Long Copse Lane, Emsworth

Additional Transport Information

Client: Land and Partners

Date: 28 January 2022

Image 5.1: Proposed footway on Hollybank Lane

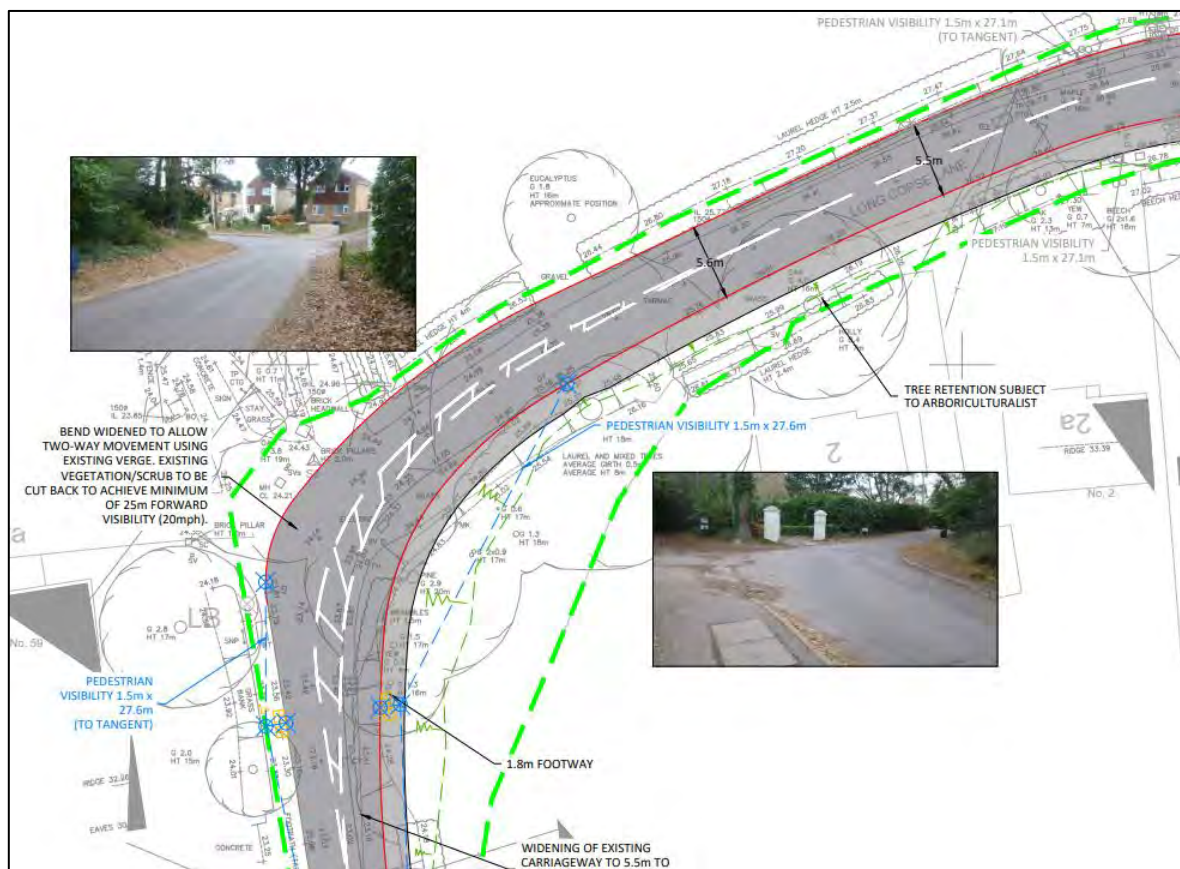
"Consideration of providing the footway within the highway land at the bend of Long Copse Lane/Hollybank Lane and appropriate crossing to BOAT should be given."

- 5.3.1 Firstly, it is important to recognise that the application will provide new, direct and continuous walking connections to all core local services and facilities. The local accessibility improvements include the works to Long Copse Lane, Redlands Lane, Wraysbury Park Drive and the measures within the WCHARs described above.

Image 8.1: Emsworth Station Cycle Parking

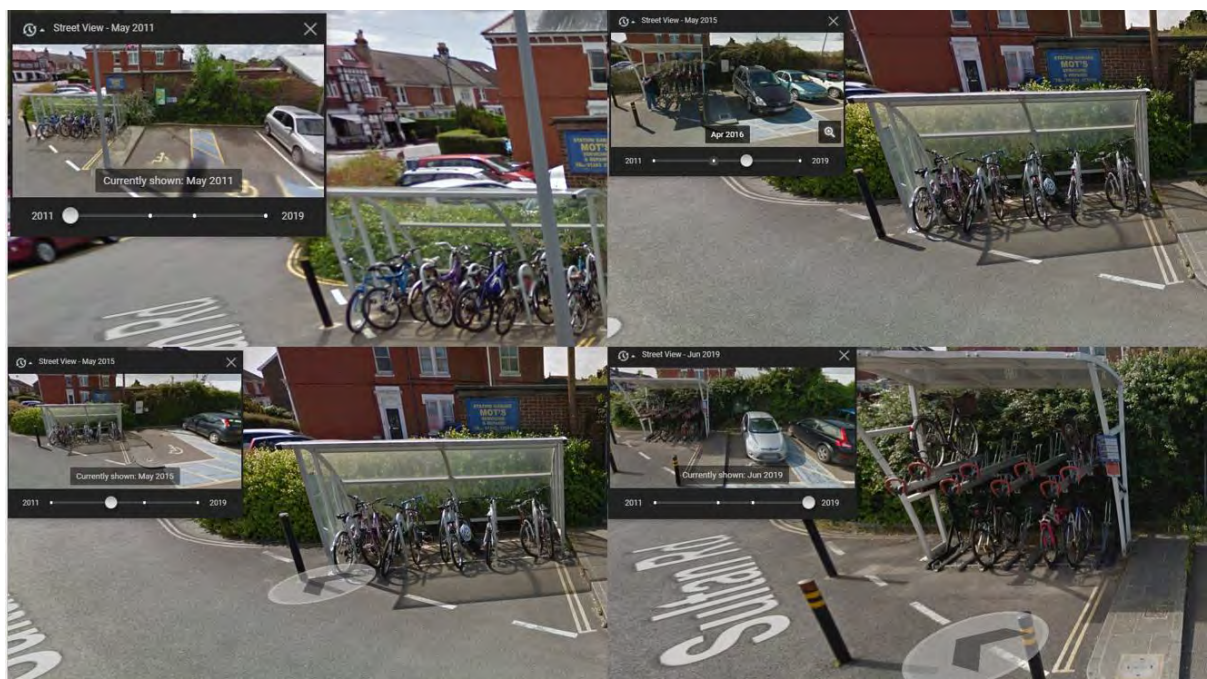
HCC Comment	Action / Information
Cycle parking at Emsworth Rail Station	
<i>Consideration should be given on whether cycle parking infrastructure is sufficient at the railway stations and whether support for additional provision would ensure travel by rail from the site would be considered an attractive travel mode.</i>	Section 8 considers cycle parking at Emsworth Station and shows that there is ample parking for cycles at the station.
Updated forecast year junction assessment	
<i>The Highway Authority require modelling up to 2026.</i>	Section 9 summarises the traffic assessment work and the full assessment work including 2026 is included in Appendix F - Traffic Assessment Technical Note
Amendments to the model builds	
<i>Model builds to be updated for: Redlands Roundabout Southleigh Road / Hollybank Lane T-Junction Wraysbury Park Drive / Long Copse Lane T-Junction Eastern Site Access T-Junction Western Site Access T-Junction Southleigh Road / Horndean Road staggered crossroad junction Emsworth Common Road / Bartons Road / Horndean Road staggered crossroad Junction</i>	Section 9 includes updated base models and results and the full work is included in Appendix F - Traffic Assessment Technical Note.

8.4.1 A series of site visits have been conducted at Emsworth Rail Station and no significant cycle parking capacity issues have been observed.

8.4.2 In addition, google street view imagery has been reviewed over the last 10 years and it is noted that cycle parking has recently been upgraded with a double height cycle parking facility installed and visible in 2019. The imagery shows the parking at the station in 2011 and 2015 on the top row and from 2015 and June 2019 on the bottom row. The June 2019 image shows significant capacity available.

TITLE: PROPOSED FOOTWAY/CYCLEWAY IMPROVEMENTS ALONG REDLANDS LANE		DRAWN: MC	CHECKED: SJ	APPROVED: SJ
		PROJECT No: ITB13525	SCALE @ A2: 1:500	DATE: 30.08.19
PROJECT: LONG COPSE LANE, EMSWORTH	CLIENT: LAND AND PARTNERS LTD	DRAWING No: ITB13525-GA-103		REV: C

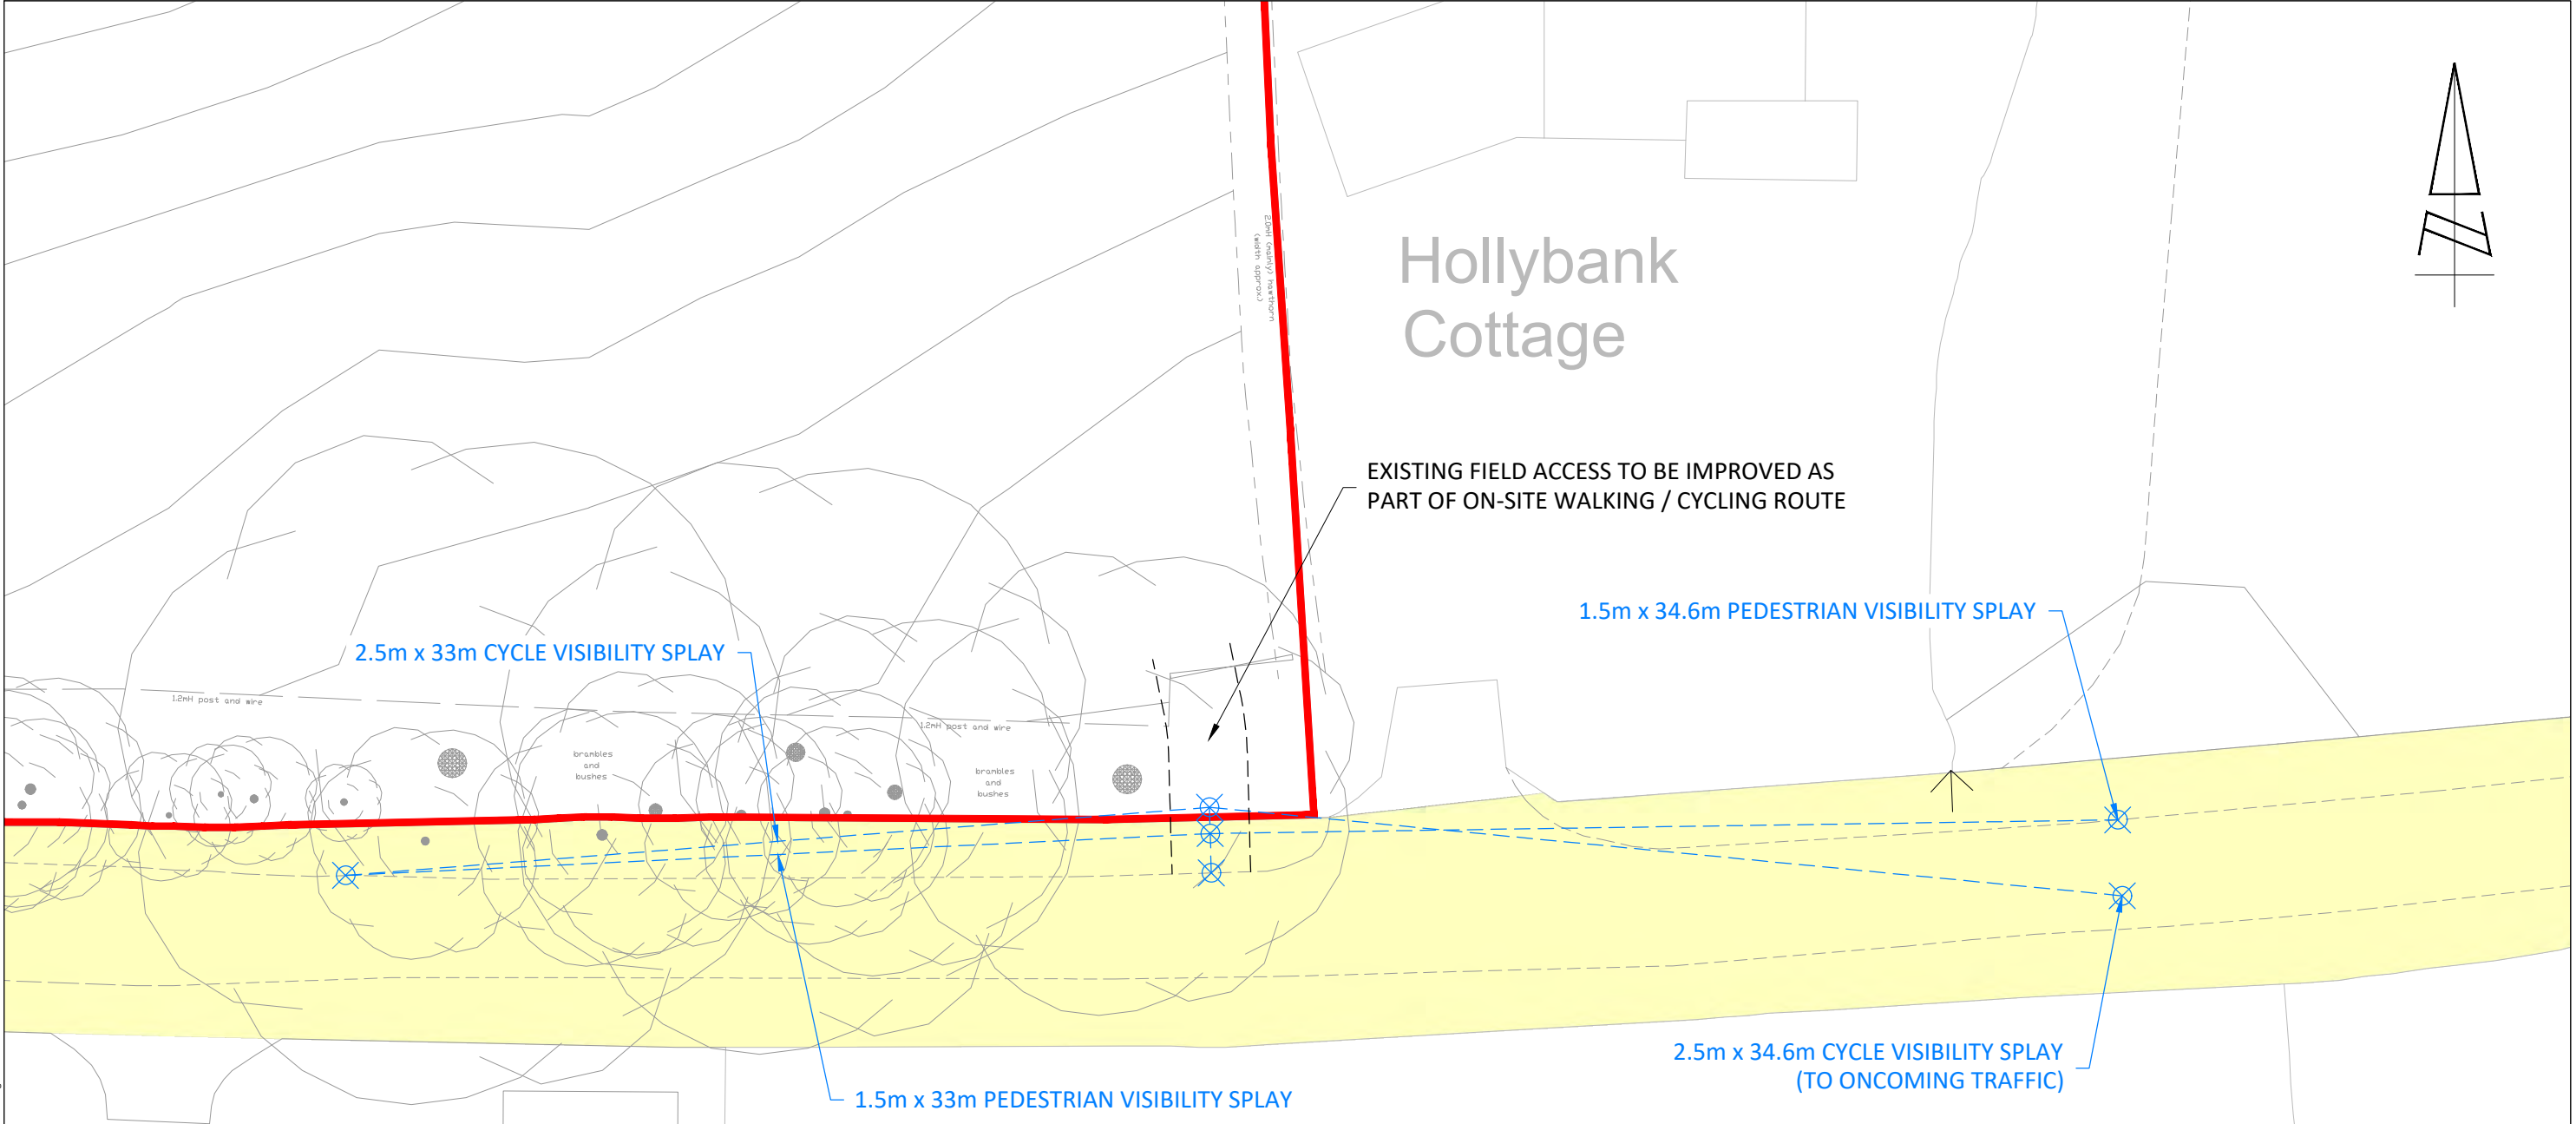
Reference is made within drawing ITB123525-GA-103 Rev A to the provision of bark chipping. This should be amended as it would not make a suitable all-purpose surfacing material as it would not be appropriate for mobility impaired, wheelchair users, pushchairs or pedal cyclists. A hogging path should be provided to be in keeping with the right of way status and provide the required suitable sustainable access link. The works to Redlands Lane to convert the existing verge shared use path would result in the felling of 3 well established trees. A full Arb assessment of these trees would need to be undertaken in order to determine their value as an asset. The Highway Authority don't generally support the removal of trees unless necessary and the designers should seek to avoid tree loss through design if possible.

6.2.1 Firstly the submitted drawing did not propose bark chippings, the reference is to the existing bark chippings that are currently laid on Redlands Lane. In any event the drawing now specifically confirms that the surface will be upgraded to Hoggin or similar to HCC requirements as shown on drawing ITB13525-GA-103 Rev C.

6.3.1 **Drawing ITB13525-GA-103 Rev C** has been updated and the footway/cycleway design now retains the trees in question with no construction works in that vicinity.

6.4.1 A Stage 1 Road Safety Audit (RSA) has now been completed for the scheme of works to Redlands Lane. The RSA is included at **Appendix E** and the design shown on **drawing ITB13525-GA-103 Rev C** has been updated to reflect the detailed matters raised by the Audit and covered in the integral Designers Response.
